NLS2005017
March 8, 2005

Subject: License Amendment Request to Revise Technical Specifications - Single Loop
Operation Safety Limit Minimum Critical Power Ratio
Cooper Nuclear Station, Docket 50-298, DPR-46

**License Amendment Request to Revise Technical Specifications
Single Loop Operation Safety Limit Minimum Critical Power Ratio**

**PROPOSED TECHNICAL SPECIFICATIONS REVISION
MARKUP FORMAT**

Figure 1
Reference Loading Pattern – Cooper Nuclear Station Cycle 22

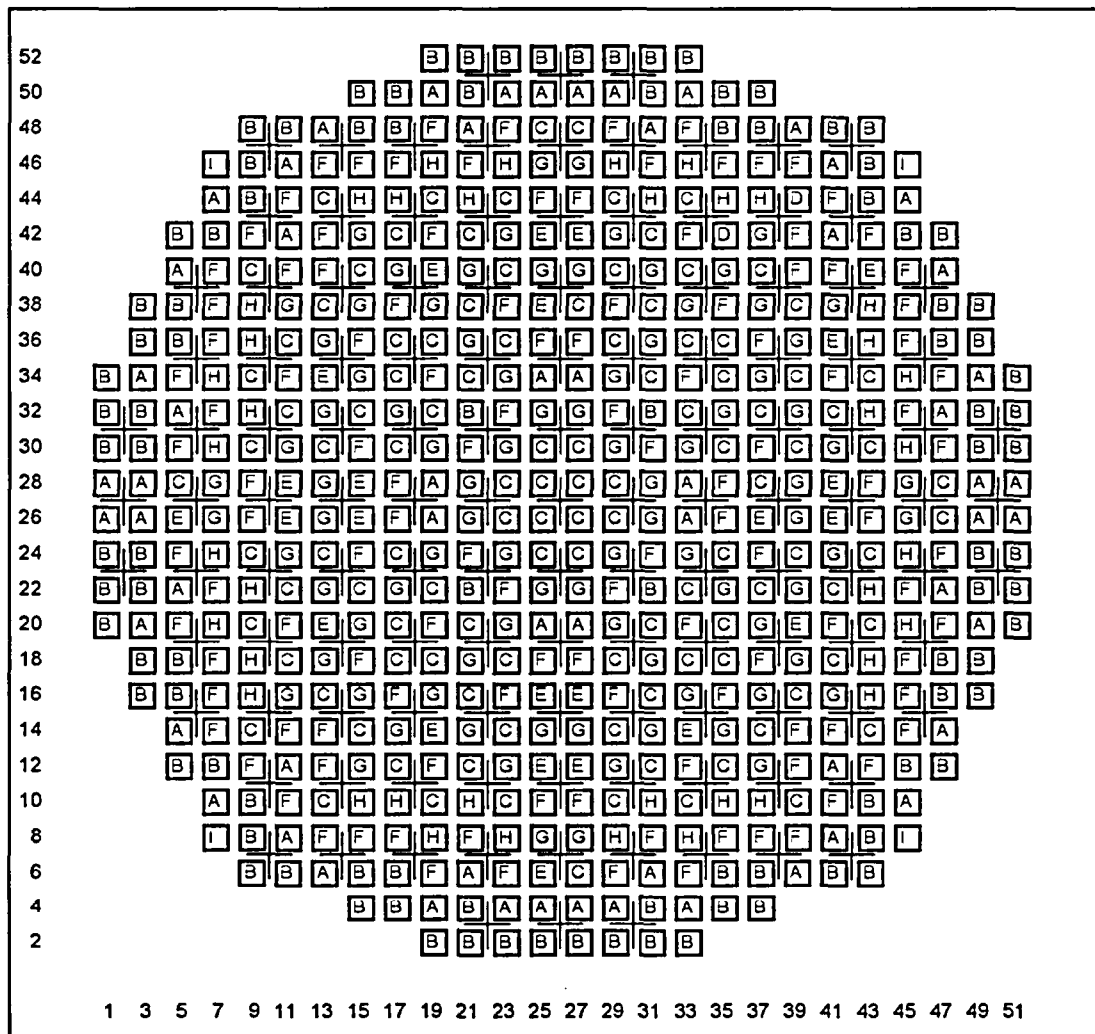
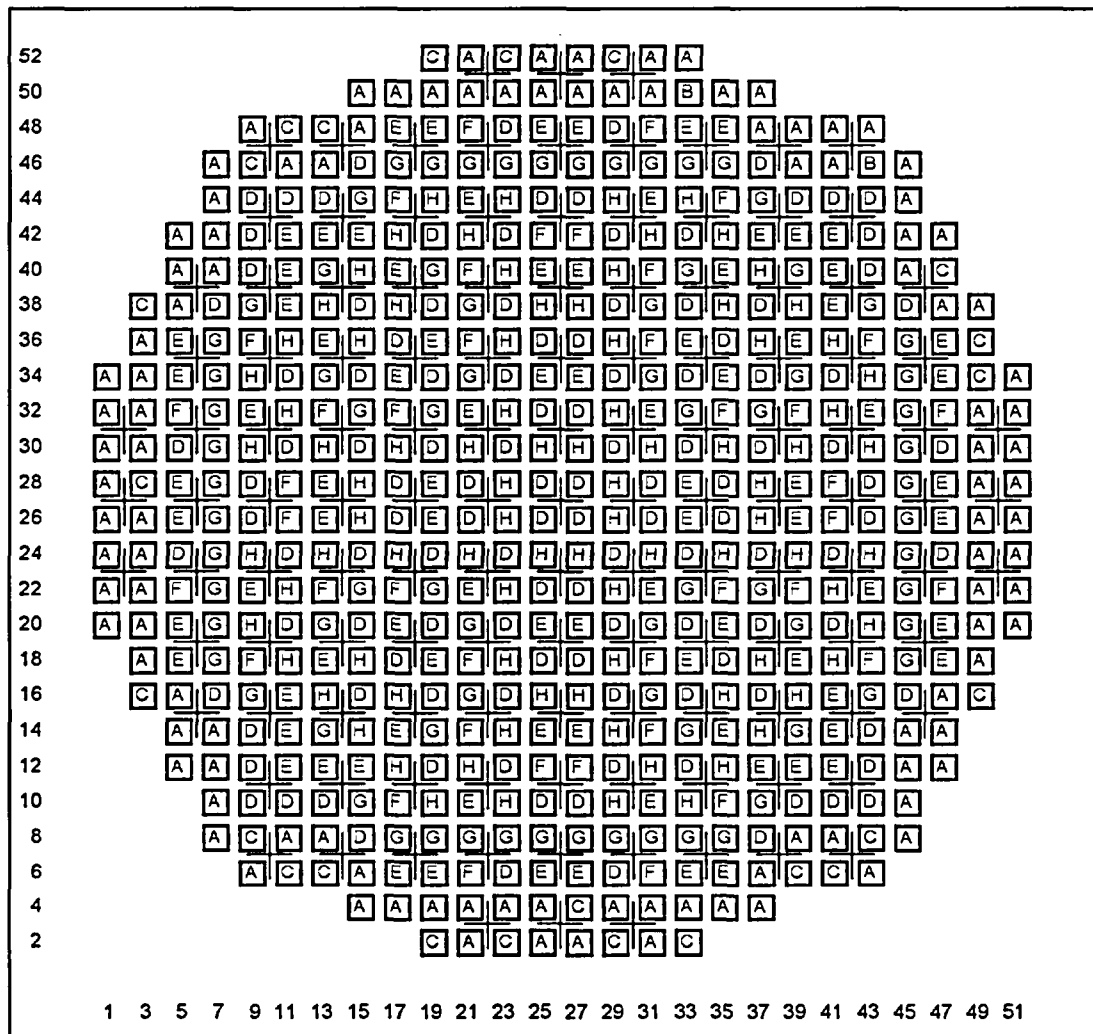
The core loading information for Cooper Nuclear Station Cycle 22 is provided in Figure 1. For comparison the core loading information for Cooper Nuclear Station Cycle 23 is provided in Figure 2. The impact of the fuel loading pattern differences on the calculated SLMCPR is correlated to the values of MIP (MCPR Importance Parameter) and RIP (R-factor Importance Parameter). The MIP and RIP values for both cycles are provided in Table 1.
